HISTORIC PRESERVATION BOARD

HISTORIC PRESERVATION BOARD MEETING

PUBLIC HEARING
102 STATE STREET (Winter Street frontage)

WINTER STREET TOWNHOMES

SHEET TITLE:
ELEVATIONS

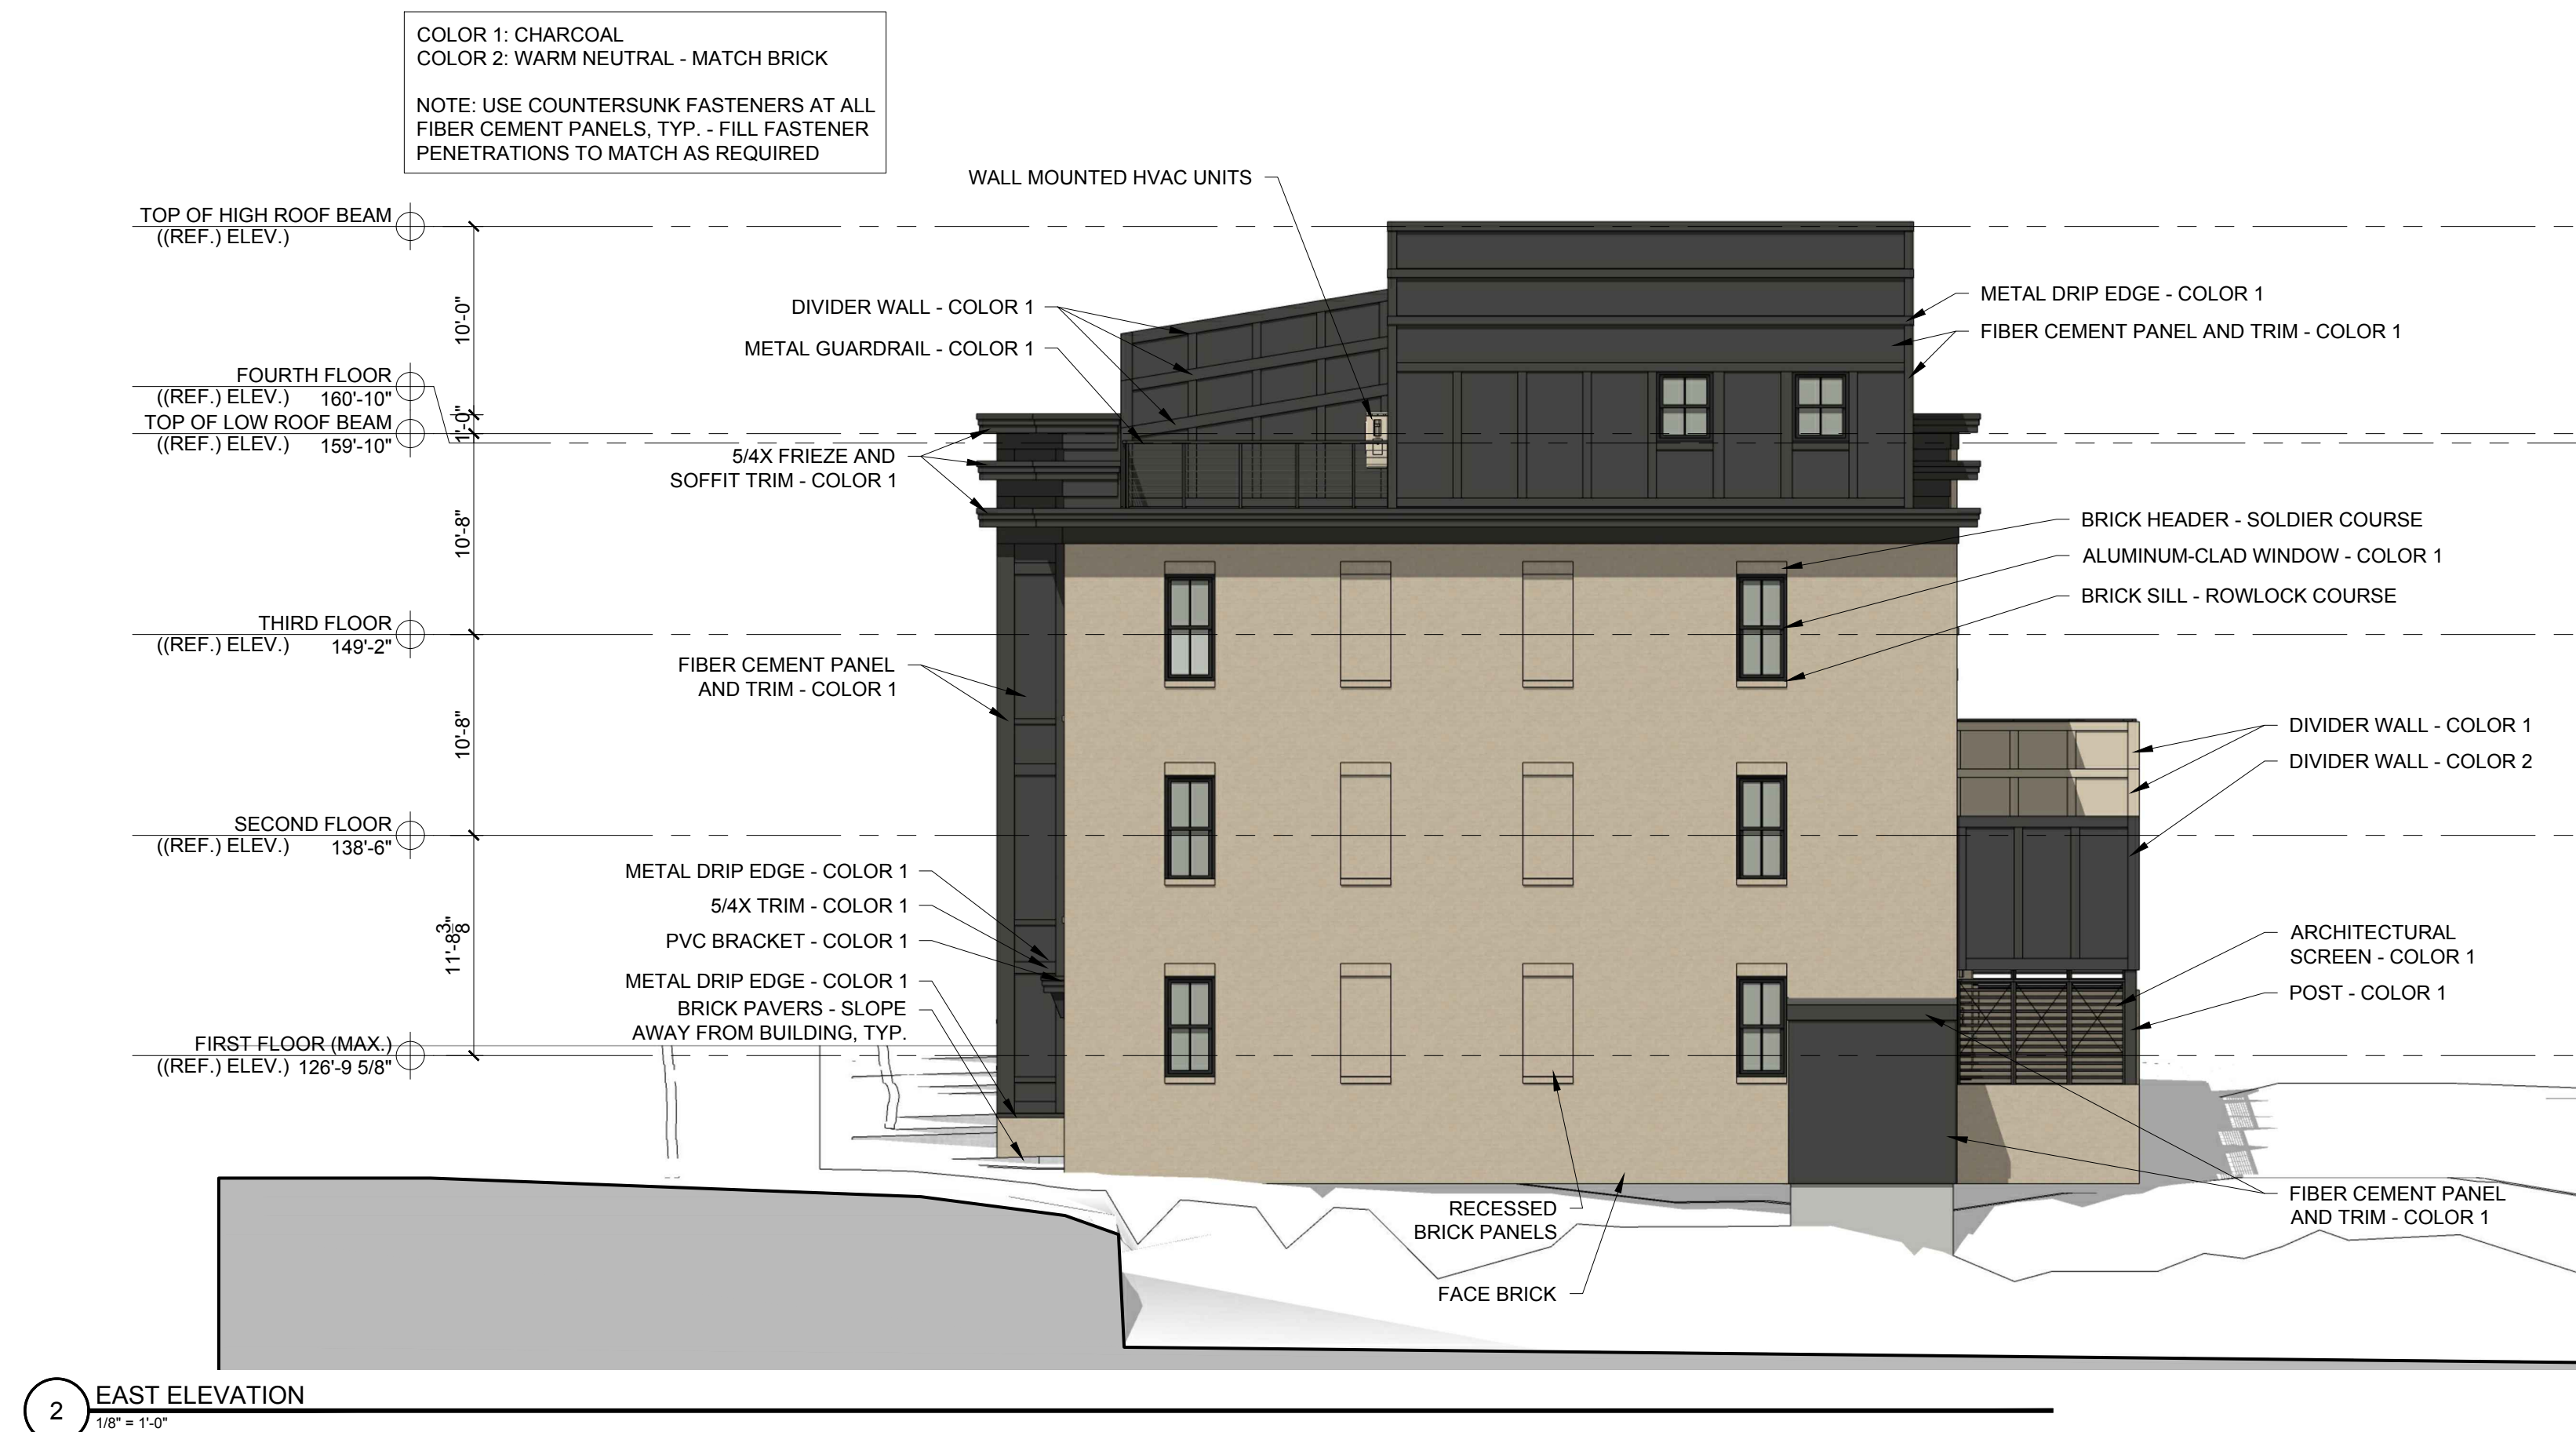
- Given the high visibility of the south elevation (which faces the 100 State Street development), Board members suggested that additional fenestration or further articulation be provided for this elevation. Mr. Senatore explained that additional windows were not allowed given the limited setback of the building from the property line.

- The presence of a projecting brick band near the base of the building to suggest a water table was found to be awkward, especially given the fact that the building steps down to follow grade. As the building steps down, the position of the water table becomes uncharacteristically high.

- The stepping down of the townhouses, while understandable and necessary, was found to be a bit awkward in terms of requiring changes in the proportions of individual entry treatments.

Brick recesses have been added that continue the fenestration pattern established at the far ends of this elevation.

The projecting water table has been eliminated.

The entry hoods are now stepped across the façade, establishing a more consistent relationship to the entry doors and transoms below.

- 1.) We have revised the East Facade to add detail and break up the masonry wall, we have added brick recesses consistency with the window pattern and proportion on the facade, as mentioned previously this wall is restricted as to the amount of glass allowed due to fire separations to the property line. We feel that this is a subtle yet effective and ordered way to add a bit more texture to this facade.

- 4.) After much discussion we have removed the water table detail, as the grades step along the facade it seems to create a cleaner facade with less mis-alignment by the removal of the water table.
